MEMORANDUM

From:	Built Heritage Officer		
Service	Green Infrastructure	App No:	252252 + 252253
Address:	L'Ortolan Restaurant, Church Lane, Shinfield, RG2 9BY		
Proposal:	252252: Householder application for the proposed erection of a rooftop extension with terrace decking to the existing main building, alongside alterations to the fenestration; the erection of a rooftop infill extension to the annex building; the erection of a detached single-storey garage with dual-pitched tiled roof and facing brickwork and stone/render to match the main dwelling; landscaping and parking alterations; and the demolition of the existing single- storey rear kitchen/service extension 252253: Listed Building Consent for the proposed erection of a rooftop extension with terrace decking to the existing main building, alongside changes to fenestration; erection of a rooftop infill extension to the annex building; erection of a detached single storey garage with dual pitched tiled roof and facing brickwork and stone/render to match the main dwelling; landscaping and parking alterations; following demolition of existing single storey rear extension.

Heritage Asset:	L'Ortolan Restaurant (referred to in on

Extracts from proposed ground floorplan, drawing P11 Rev.A of 252252.

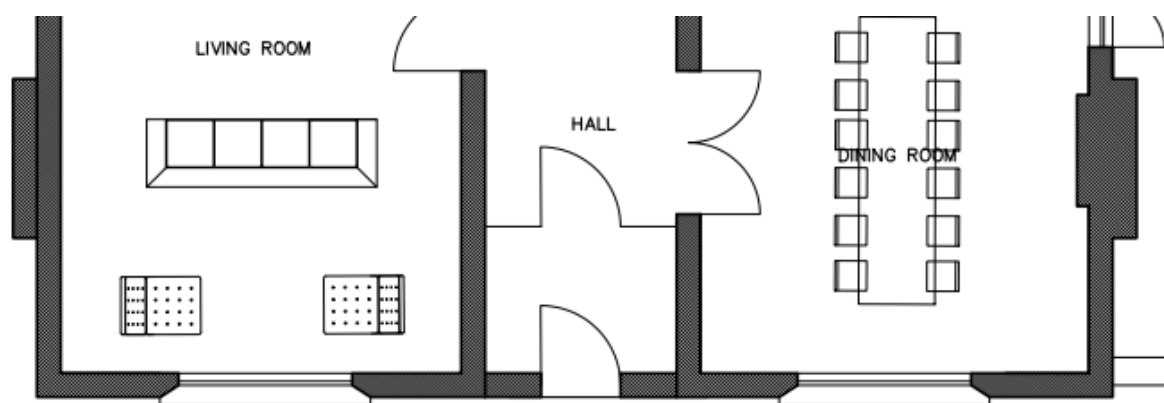
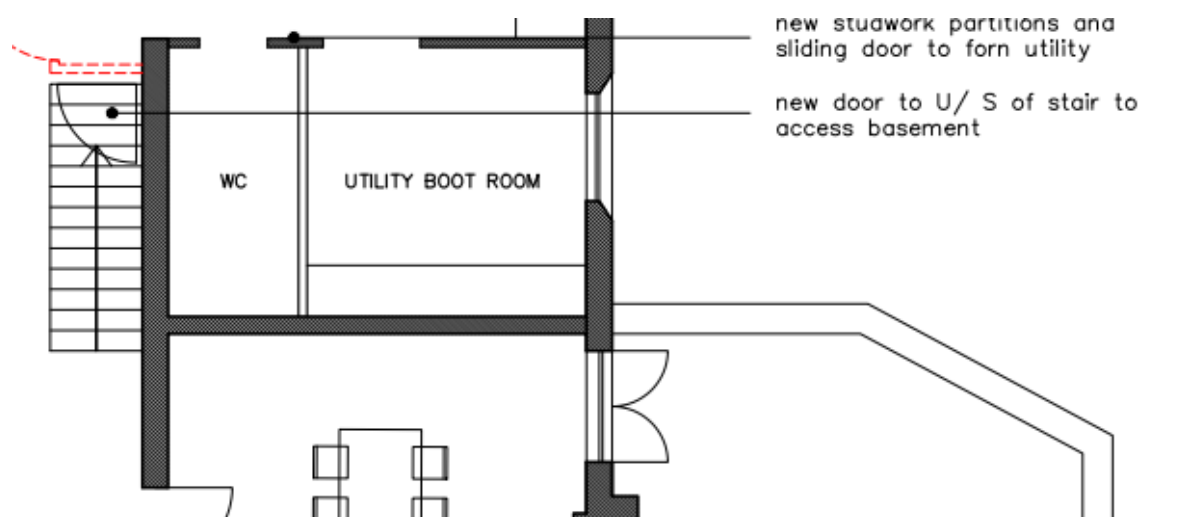
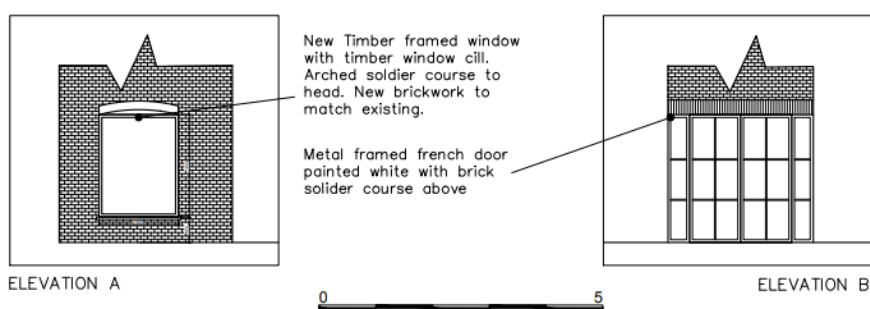
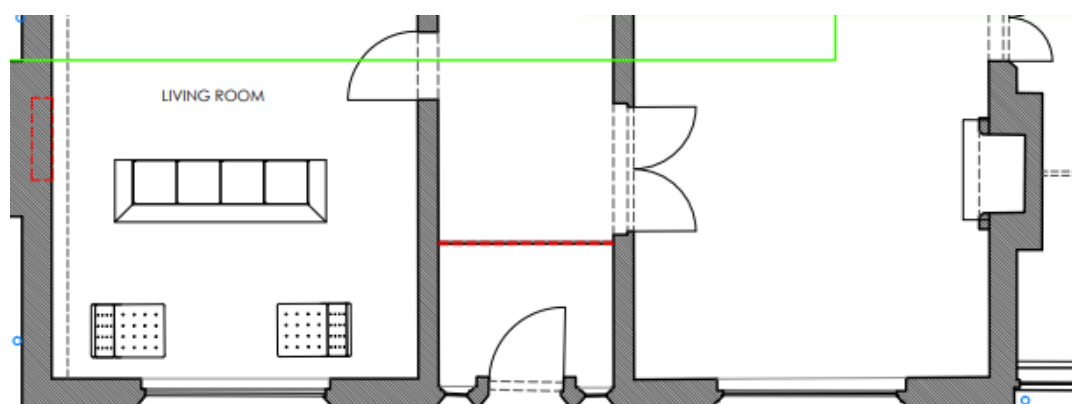
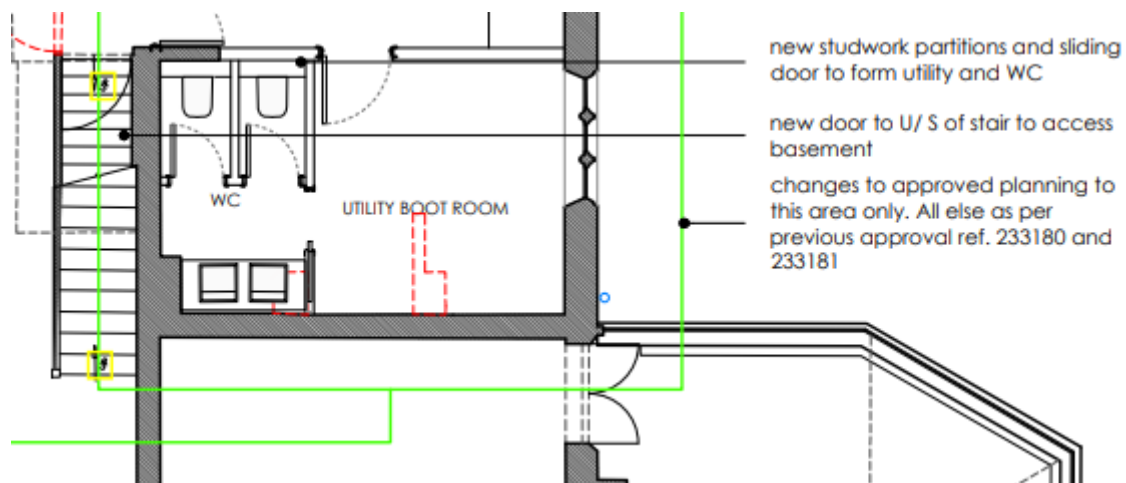
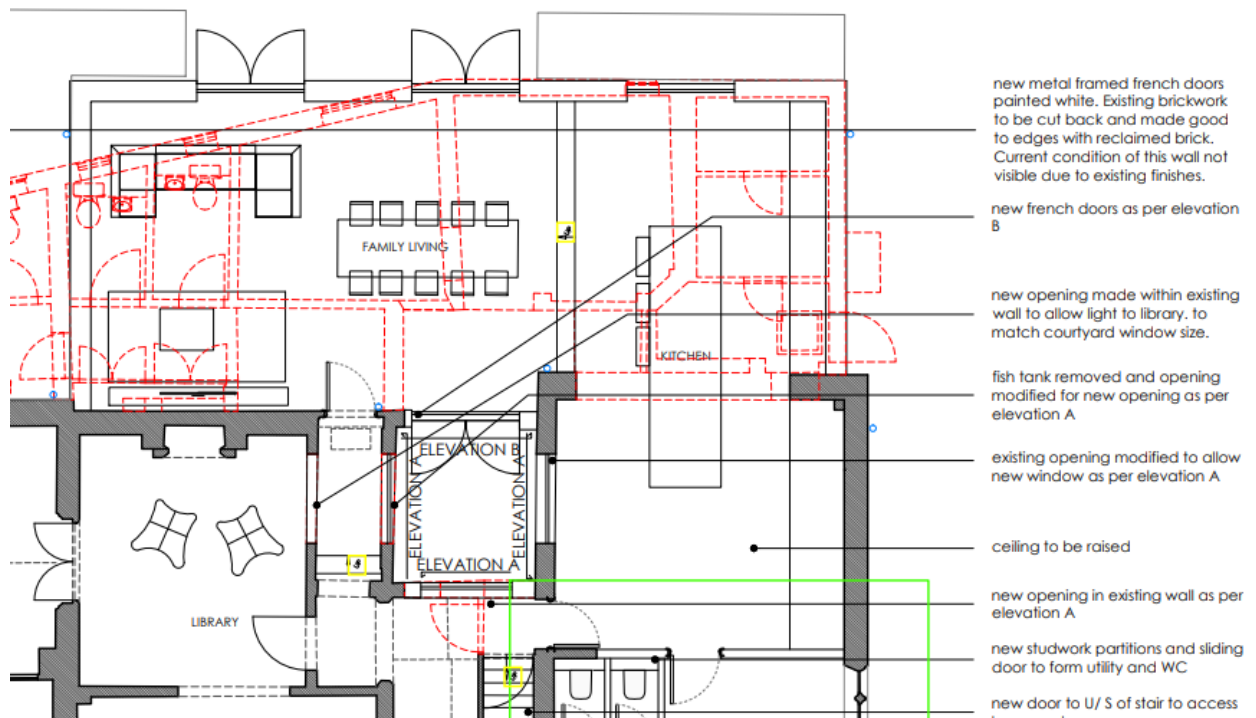
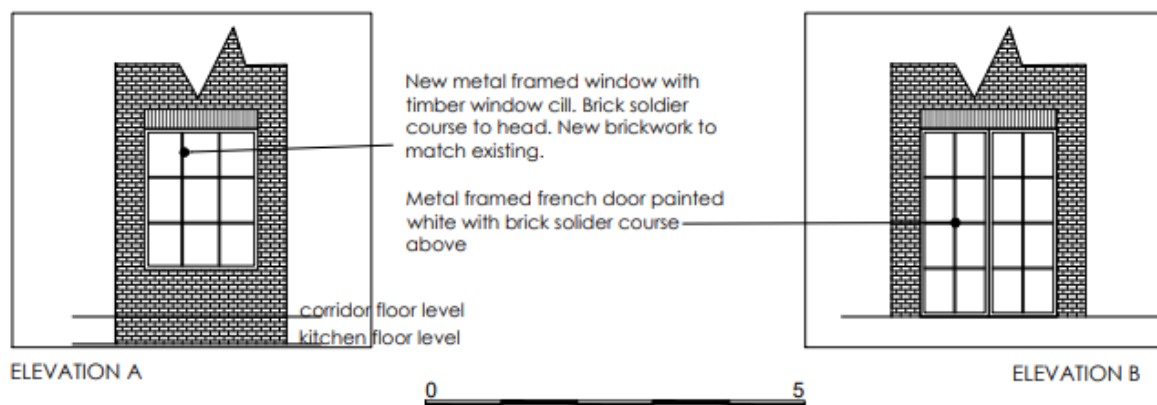
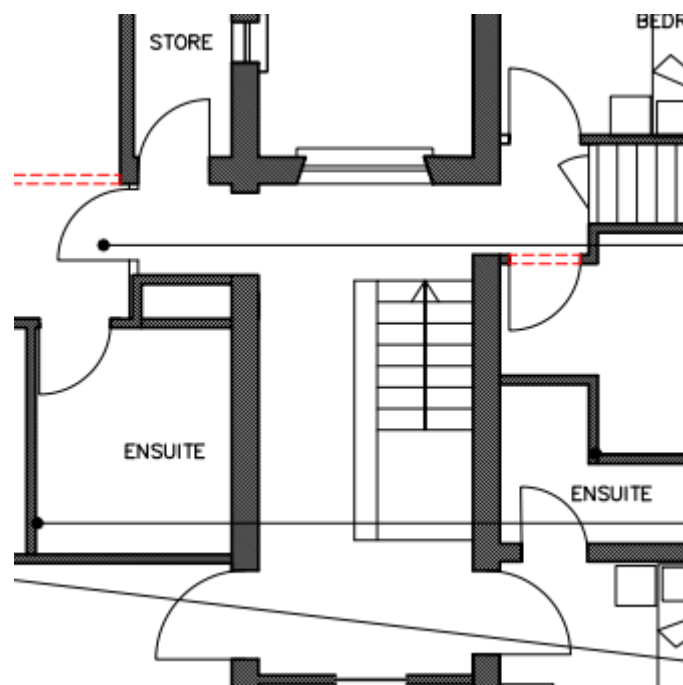
- Noted changes to the form and size the window/openings to the enclosed courtyard, what reason for the changes?
- On the application drawings, the front door is hung off the opposite side to that of the approved plans which show the glazed entrance lobby screen retained but is now shown to be removed. Would wish clarification as to the reason for the changes?
- Changes made to the layout of the utility boot room to that already approved. No justification provided for the changes.

Extract from proposed first-floor plan, drawing P12 of 252252.

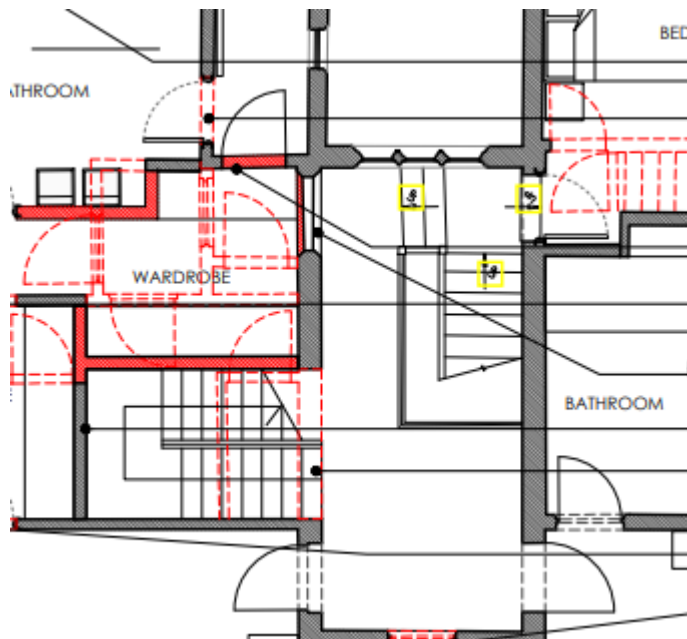
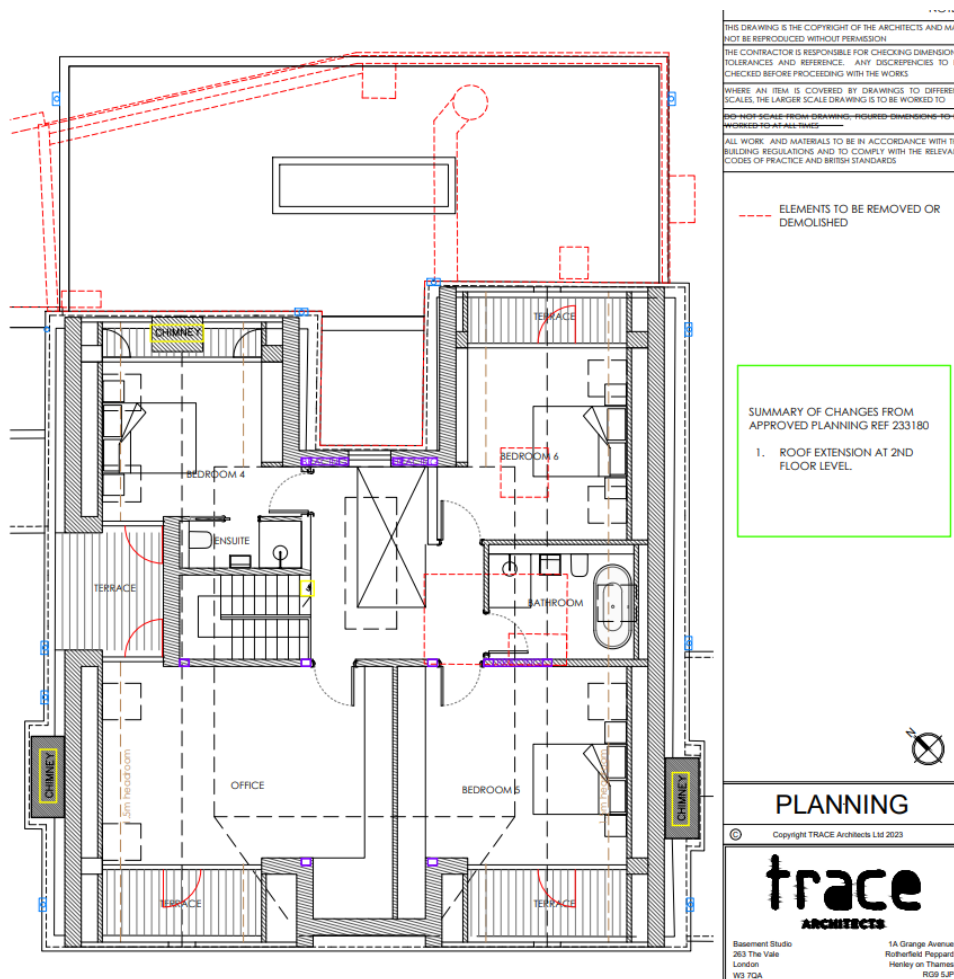
- Not clear on the above plans the reason for the difference to the stairs (additional steps, form) and landing stairwell?
-

Extracts from approved proposed attic floor plan, drawing P13 rev A of 252252.

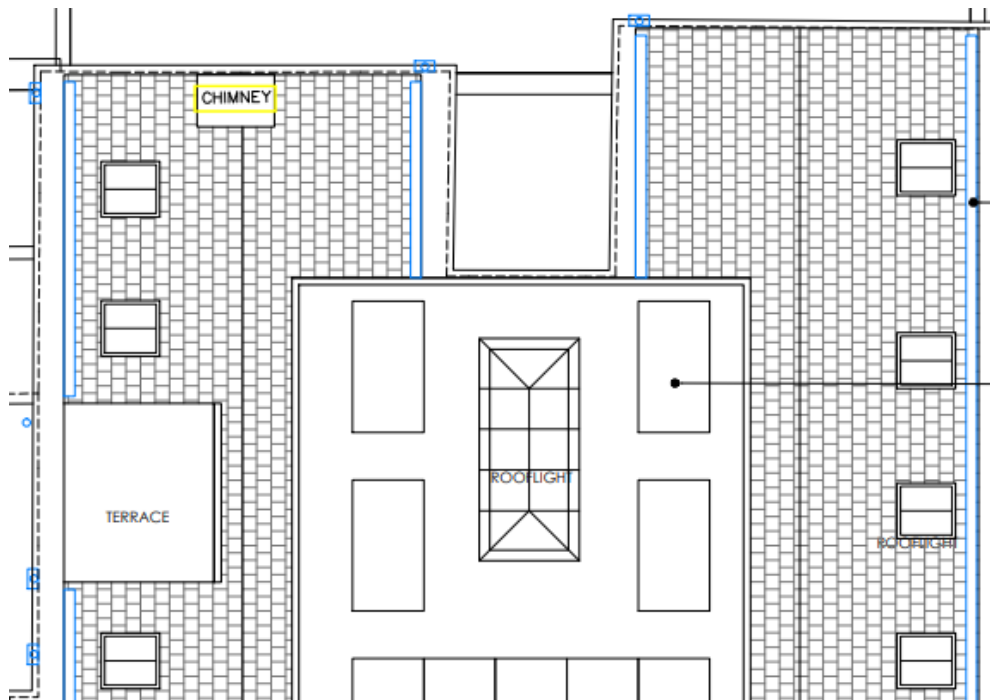
Also, it is worth mentioning here that with respect to the proposed attic floor plan (drawing P13 rev A of 252252) what the internally diagonally crossed rectangular detail is intended to represent as it is suggestive of an opening through to the first floor above the main staircase. As such clarification is requested with respect to that detail

- Not clear on the above plan what the blacked lined rectangular shape, with diagonally drawn line within, is meant to represent?

Extracts from proposed roof plan, drawing P14 rev A of 252252.

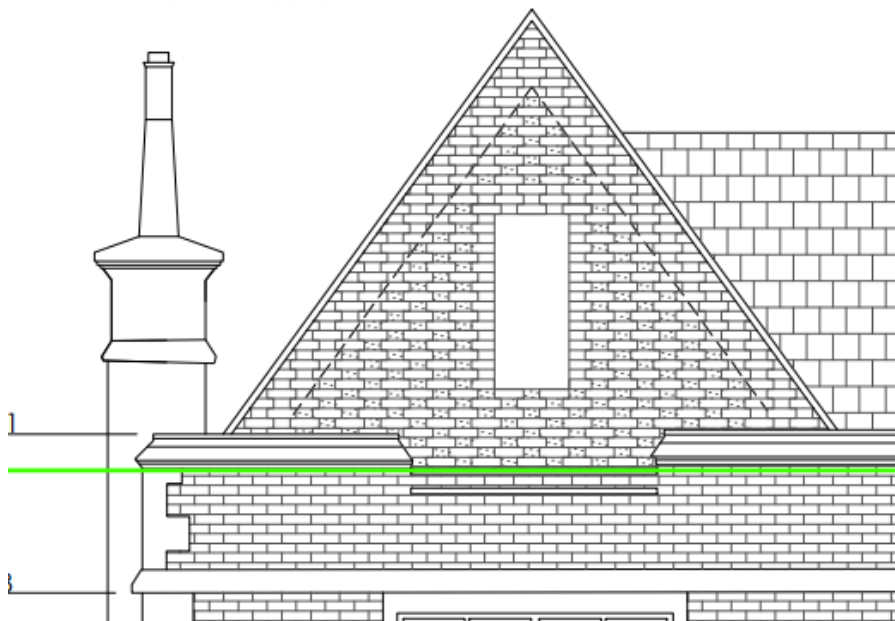
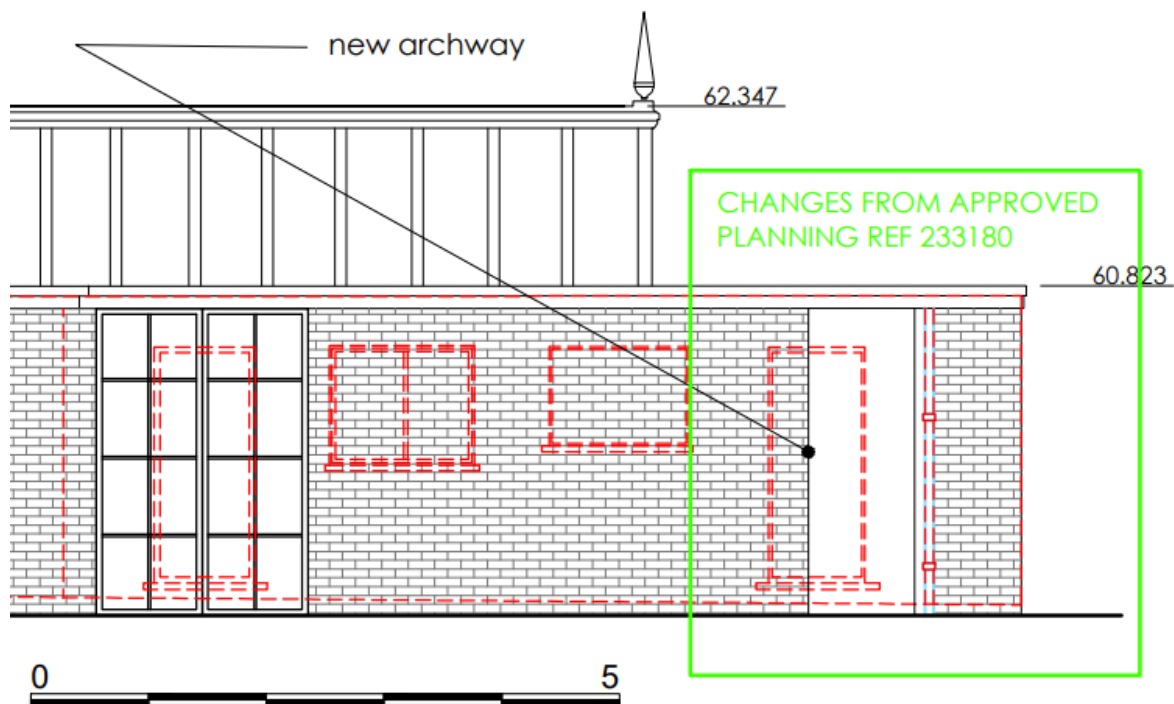
- Question is how rainwater run off to roof by the terrace cut out is to be handled?

Extracts from proposed elevation plans, drawing P15 rev A of 252252 showing flat topped new archway opening.

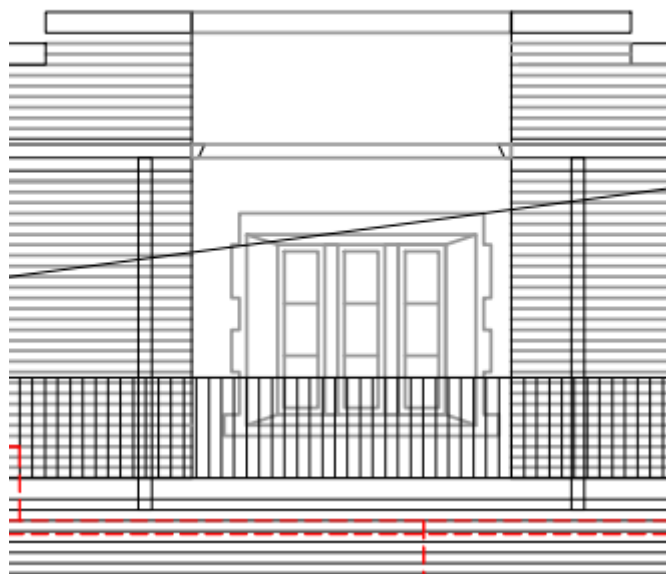
On the same drawing is shown a new opening is to be formed in the section of the attached historic (listed) brick garden walling to the side of the building beyond the existing modern conservatory and forms the back wall to, which is to be retained, following the removal of the non-historic restaurant addition to its NE elevation are removed. Here would wish to raise the question as to the flat-top form of the new 'archway' opening.

- Would question how the flat-topped archway is to be formed, so as to have the stone banding/coping carried over it?
- The form and potentially position of the previously approved new French door opening appears change on the application drawings.

Extract from proposed elevation plans, drawing P15 rev A of 252252. of rear window to staircase.

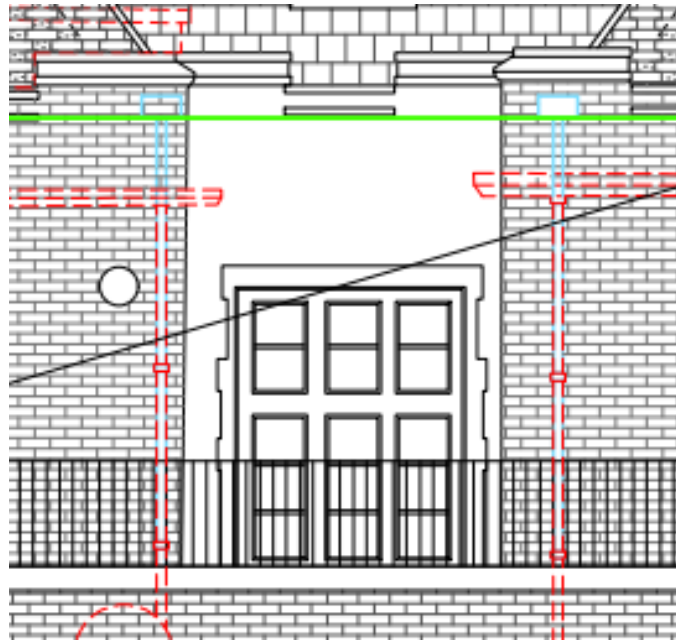
- Explanation need for the notable difference in the rear first-floor window to the staircase and the parapet wall crenulation detail from that of the approved drawings and those now being proposed?

- Clarification is required concerning the rainwater hoppers and down pipes/ The blue outlines appear to represent new rainwater hoppers set higher up on the parapet brick (for the new roof rainwater channels) and the red-dashed lines represent the existing rainwater element to be removed. However, it is not at all clear on the drawings the apparent intention for new downpipes in the same location as the existing.

- Not clear what the white infilled circle on the rear brickwork elevation to the left of the staircase window is? Photos would appear to suggest an existing flue presumably related to the former teaching kitchen in the rear first -floor room. If now redundant flue would argue it be removed.
